Appendix A

NOP and Comment Letters

- What Bates means to you and why the ridge should be preserved
- Why the EIR needs to assess impacts to wind and recreation
- Why the City should consider alternat ***Put the proposed trail along the highway and save money while preserving our precious paragliding site. I travel there at least once a year to paraglide and spend a lot of money in Carpinteria. If the site is gone, so am I. Andrew Craig, Virginia BATES RINCON BIKE PATH, 11/17/2020***
- ives like the North side of Bates.

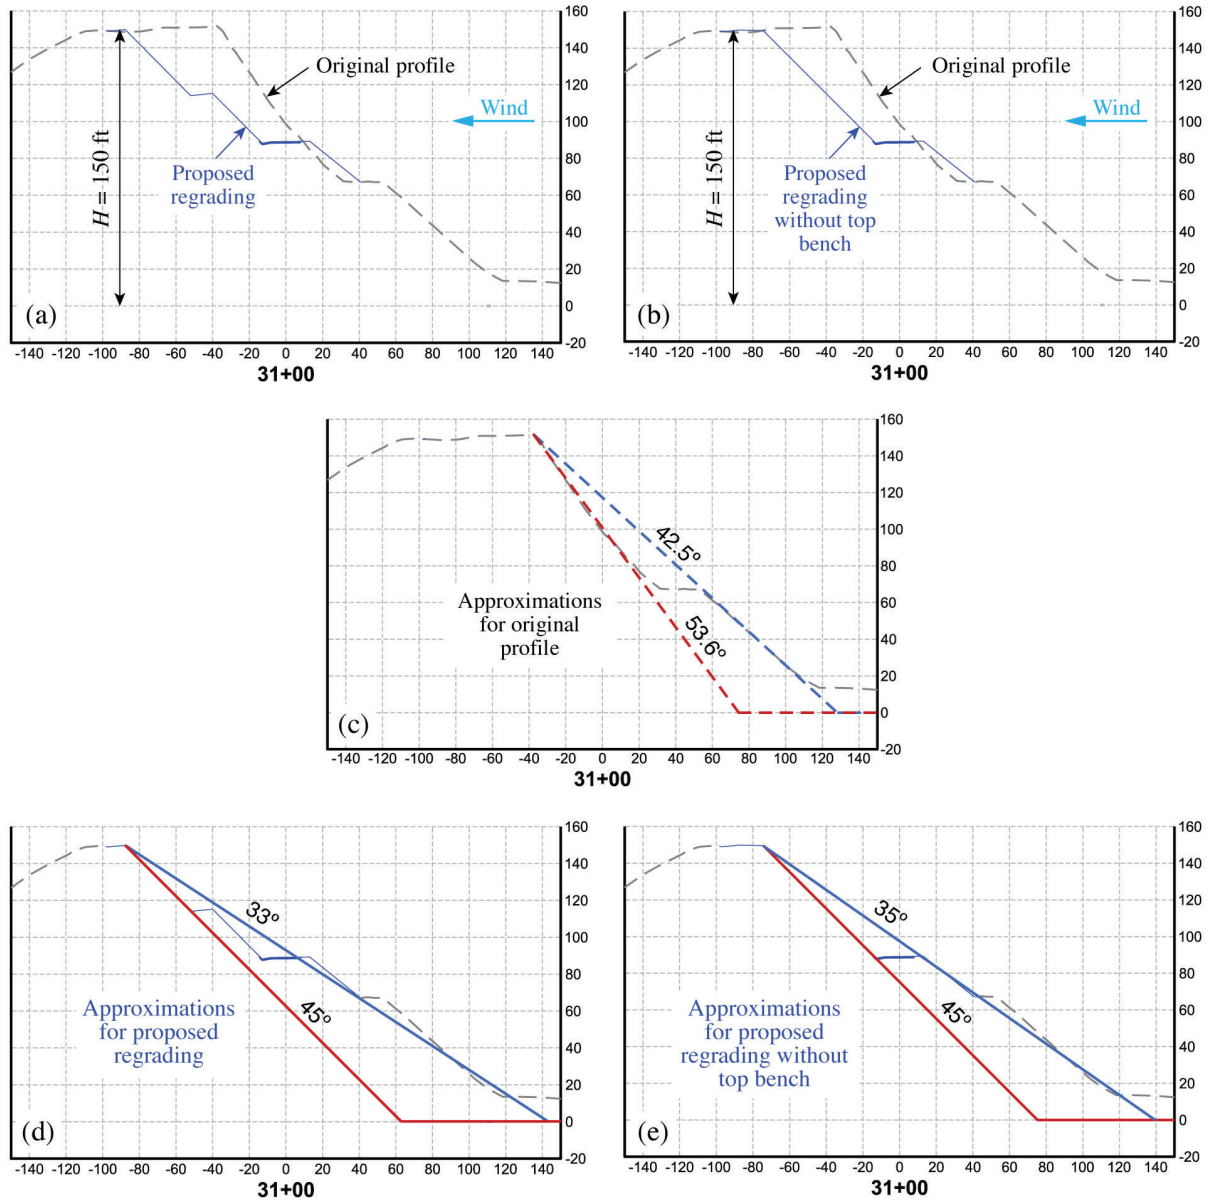
The analysis is based on a representative two-dimensional section of the Rincon bluffs, shown in figure 2(a). To approximate the topography, two approaches are used and compared. The first approximation defines a mean slope, which joins the foot of the bluffs (where the topography rapidly departs from horizontal) to the top of the topography; this approach is consistent with

An alternative proposed regrading was also considered, which essentially removed the bench closest to the top of the topography. This is sketched in figure 2(b,e), and only implies a change in the mean slope.

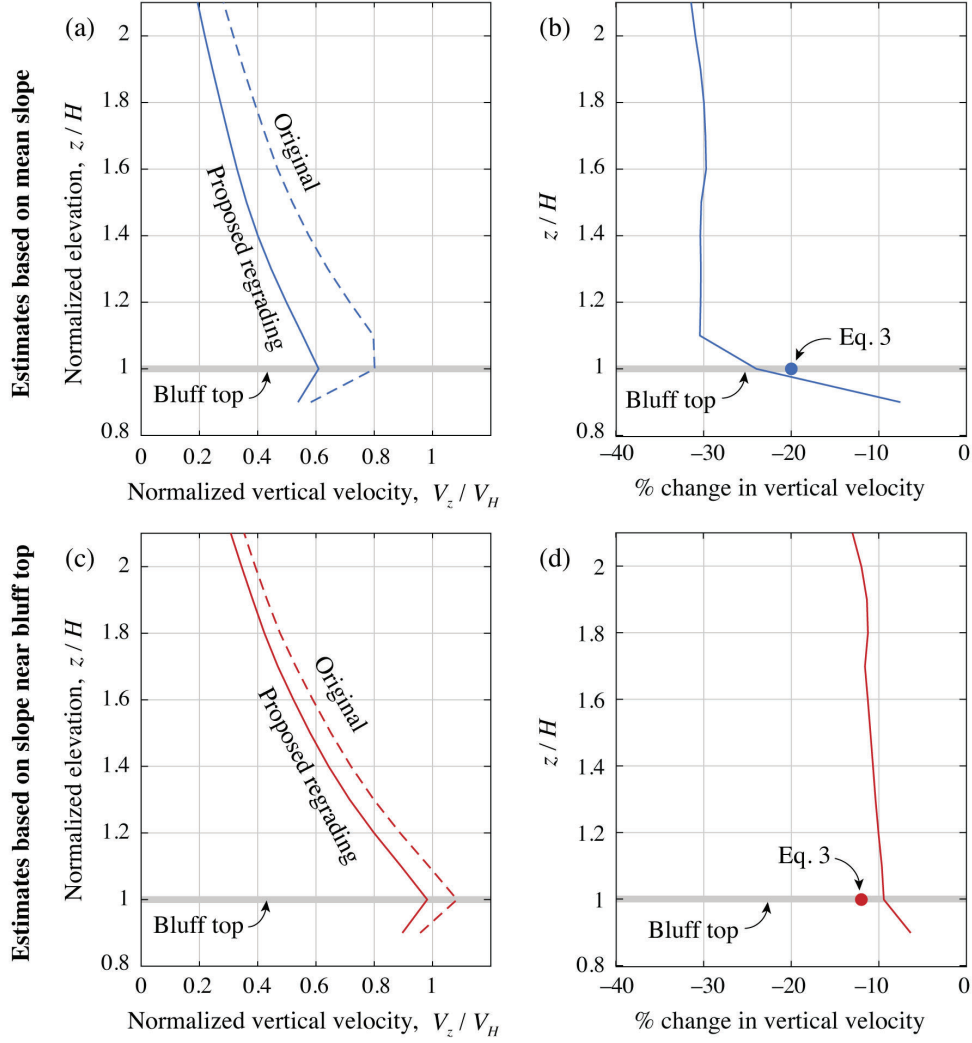
deduce vertical velocities V_z . The maximum vertical velocities at each z are shown in the left-hand panels of figure 5, for both the original bluff and the proposed regrading. The right-hand panels show the percentage change at each z . The analysis based on the mean slope predicts that the vertical velocity will be reduced by approximately 30%, whereas the analysis based on the near-top slope predicts a reduction of around 10%. Panels (b) and (d) also show the simple prediction from equation 3; since this result is valid only close to the slope surface, we display it using circles placed at the bluff top.

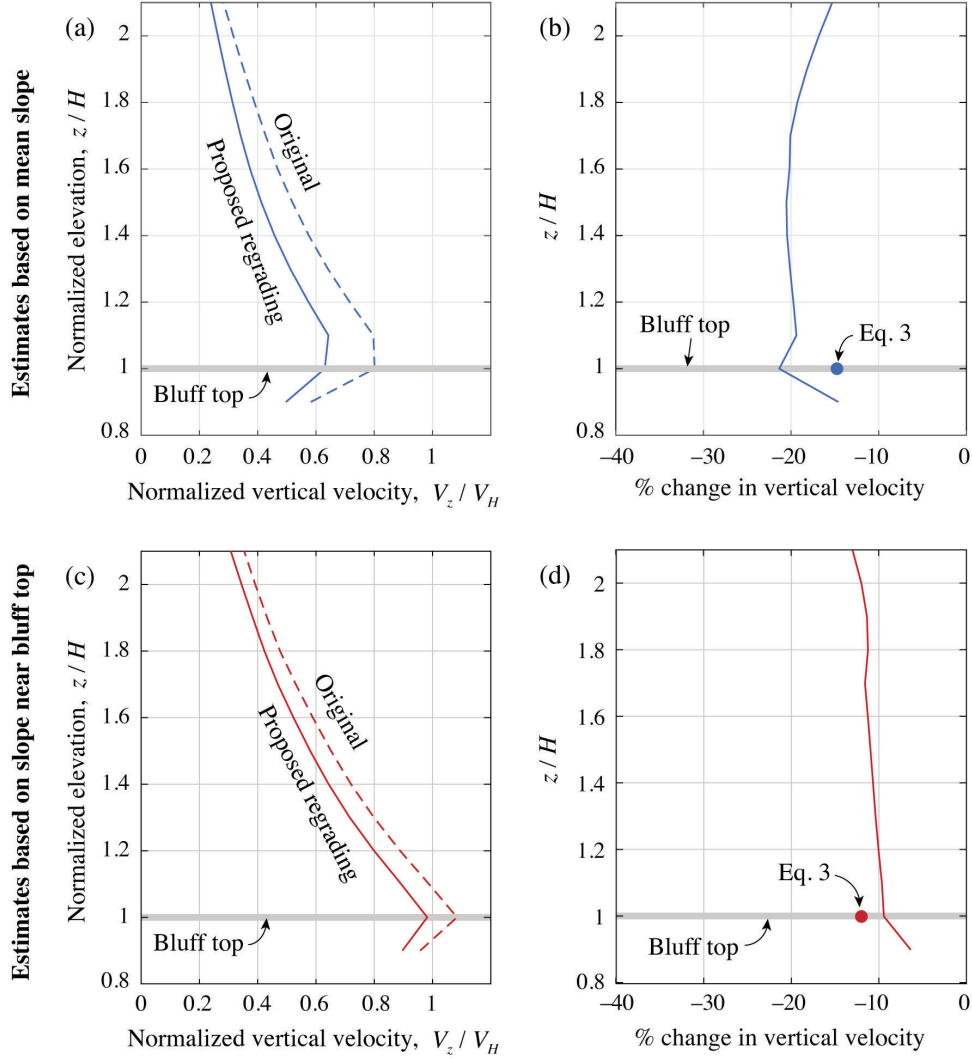
For the regrading that involves one fewer bench, the mean slope increases relative to the initially proposed regrading, which brings the predicted reduction in V_z to around 20%, as shown in panel (d) of figure 6. For completeness, predictions for the near-top slope analysis are also reported, although they are the same as in figure 5.

Photo 1: Example provided by Jeff Lindgren: Cabrillo Blvd. Application at Rincon Park would allow recreational users to stop in the park:

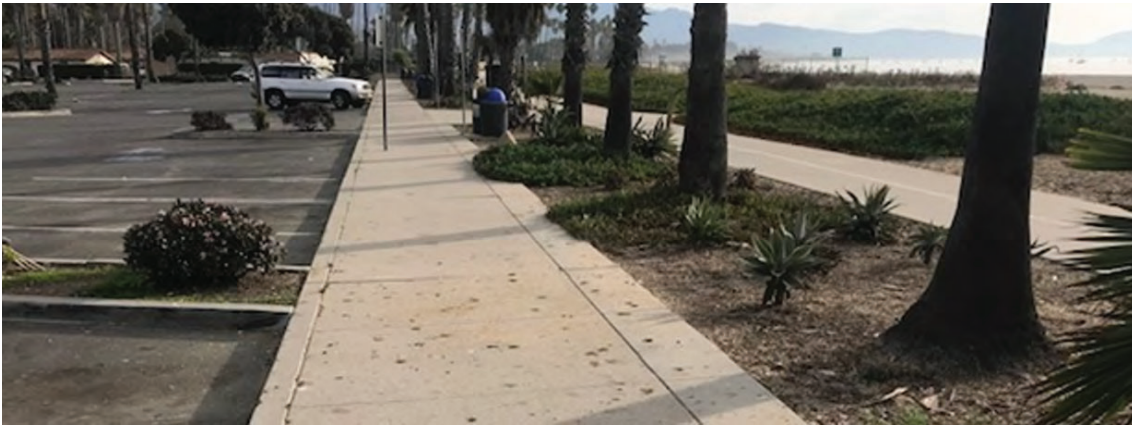
1. “Yellow line” trail on ocean side of parking lot for recreational users stopping at park
2. “Orange line” trail on freeway side of parking lot: for “pass though” users

Note: sidewalk adjacent to parking lot and separate beach way trail on ocean side of planter

Exhibit 2: Typical Cross section from Caltrans Highway Design Manual with some items of interest for 'Orange Line' alignment.

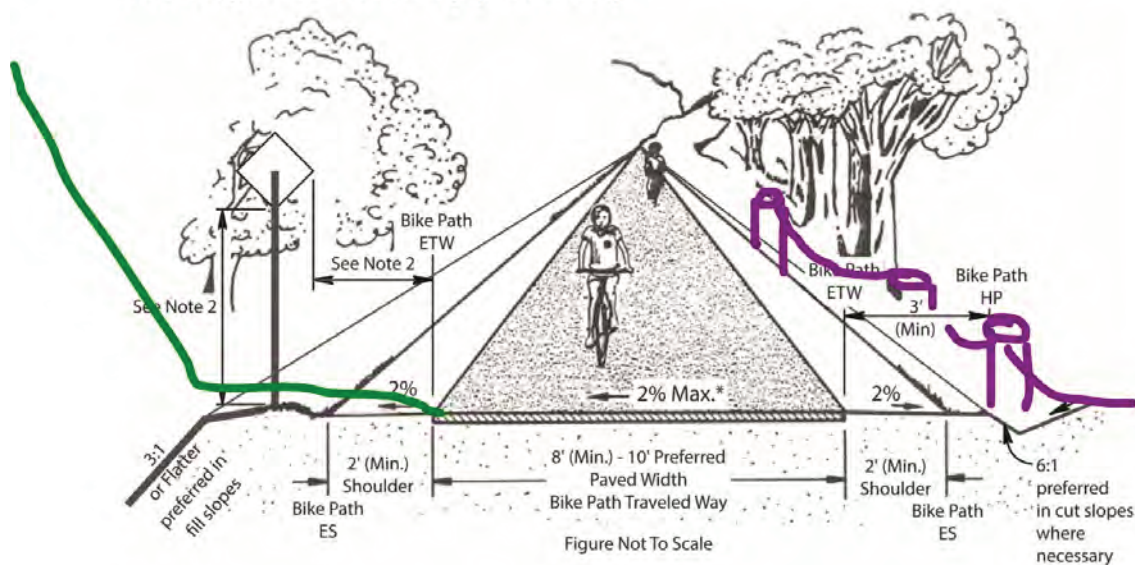
Photo 6: Santa Barbara Harbor: Chain-and-post barrier concept for use at Rincon County Park
